REPORT OF THE IRRIGATION & POWER TEAM  
ON  
**LAKKAVALLI PROJECT**  
(MYSORE STATE)

COMMITTEE ON PLAN PROJECTS  
NEW DELHI

NOVEMBER 1957.

REPORT  
ON  
LAKKAVALLI PROJECT  
MYSORE STATE

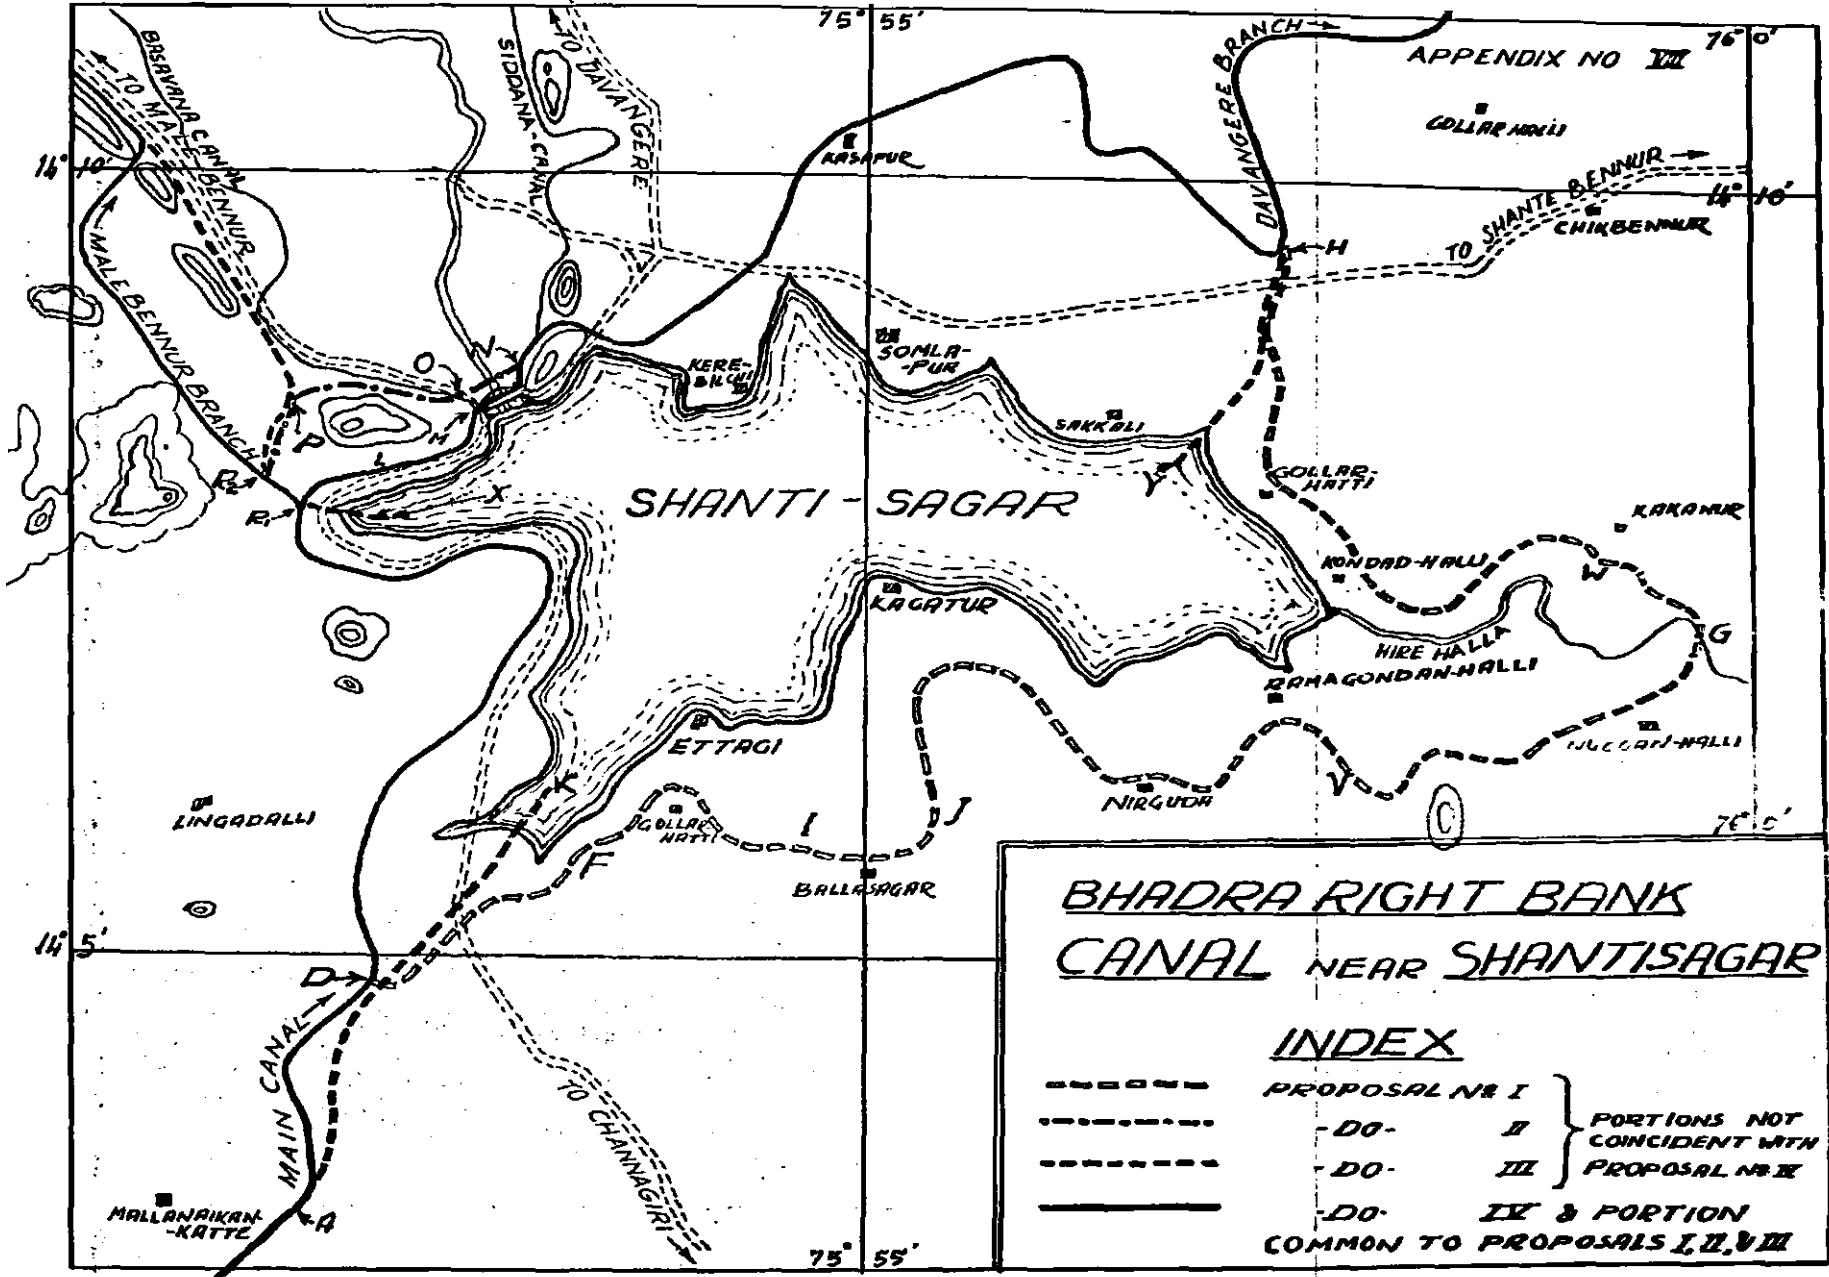
- (III) The Right Bank Channel to terminate in the tank as shown by DK in the plan. The Malebennur Branch Channel to take off from the tank along XR1 R2. The Davangere Branch Channel to take off from the tank along YH.

with a head of 90 ft. must cost more than Rs. 16 lakhs. With such high head it would be obligatory to use steel pipes, encased in concrete and the design does not provide for such construction. This major C.D. work may cost as much as Rs. 40 lakhs. This, together with the increased cost of constructing the channel length PN, mentioned earlier, is likely to increase the cost of proposal II by another Rs. 25 lakhs at least, bringing the total cost to Rs. 152 lakhs.

(a) The water level in the tank will remain at a high level throughout the year and there will be a dense growth of weeds along the shallow fringe of the lake, favourable to mosquito breeding, giving rise to a serious incidence of malaria. In the Mysore State great importance is attached to the question of health of population and to appreciate the implication of this question it is worth-while recalling the fact that 112 old tanks in the command of the Irwin Canal, ex-Krishnarajasagar reservoir had to be breached to check malaria. The condition of the affected villages has been vividly described in official reports. "Tanks in the atchkat areas situated below the channel will be full always due to the collection of seepage water from the channel, as well as from the atchkat above. Incidental to this the water table rises, dampness comes up and marshy areas are formed. All these conditions are so favourable for the breeding of mosquitoes that the area soon gets malarial and the deadly disease overtakes the population resulting in heavy mortality. Awful stories are told of the sufferings of the people due to the scourage of malaria. Several villages have gone out of existence. In some, it is said there are no male members at all, all of them having succumbed to malaria. It is even said that the young men of some of the villages affected by malaria are denied brides for marriage from other villages. The evil does not confine itself to human beings only, but has spread to cattle also. There is a terrible growth of weeds in the shallow portions of the tank water spread, which gives rise to enormous growth of snail population. The cattle that go to the tank for drinking water, catch a kind of disease called 'Liver Fluke Disease', which is due to the snails harbouring in the weeds of the tank. The breaching of tanks and other anti-malaria measures have gone a long way in mitigating the evil and restores the people of the tract to their original health and stamina in a large measure". In the face of these facts, based upon previous experience, it is not surprising that there

is a vehement opposition to the proposal of tailing the channel into the Sulekere tank.

It has been argued that by regulating the discharge of the Right Bank Channel the level of water in the tank could be varied at will and thereby the growth of weeds prevented. This proposition is not free from practical difficulties. The main canal has a discharge of 2,500 cusecs and is 58 miles long and the effect of its regulation will take a considerable time to reach the tank. When the tank is full from the discharge from its own catchment there is every possibility of wastage of canal water over the waste-weir. From the tables prepared showing the operation of the channels and the resulting levels in the tank it is seen that the variation in the water levels is of the order of a very gradual variation of 4 feet only, as against a much larger variation which occurs under the present conditions. Any attempt to introduce larger variations by manipulating the discharges of the main canal will affect the generation of power resulting in a direct loss of power and of revenues.

(b) The Malebennur and the Davangere Branch Channels taking off from the tank will have their bed levels several feet lower than those in proposal II. This factor not only results in a substantially increased cost of excavation of the channels in proposal III but to gain the same command they have to be excavated in a longer lengths. This must also result in an additional cost, which has yet to be computed.

7. Proposal IV. This proposal has none of the disadvantages of proposal III and the objectionable features of proposal II. This possibility of taking the Davangere Branch over the Sulekere bund has been examined by the Project authorities and an estimate of cost prepared. It had however been considered that it was undesirable to take the channel over the bund because the bund was old. The Team considers that it is possible to construct a reinforced concrete duct on the bund without affecting the security of the bund or causing any danger to the tank. There should be no risk in taking the channel in a concrete trough over the bund, with copper strip joints to allow for any slight settlement. The load on the foundation is of the order of half a ton per sq. ft. only. The cost of this proposal may be about Rs. 113.5 lakhs. The advantages of this proposal are:
